# Imray Correction Notice ICC61-2

5 June 2019

## Chart C61 WGS 84 Edition 2016

Block correction for C61(Plan H)  
ILNW 418/16

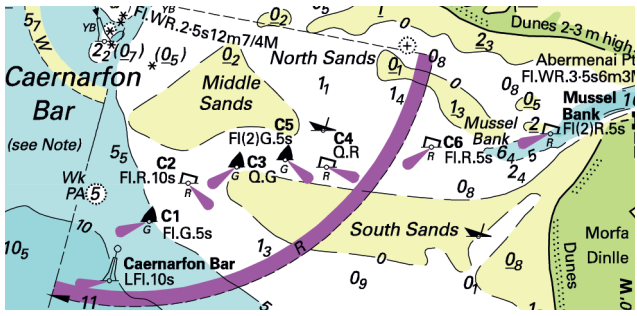
- 7 Constable Bank N**  
Delete BY North pillar Lt buoy **North Constable** in 53°23'72N 3°41'41W. (ILNW 384/16)
- 8 Caernarfon Bar (Plan H)**  
Insert accompanying block correction centred on 53°07'14N 4°22'82W (ILNW 418/16)
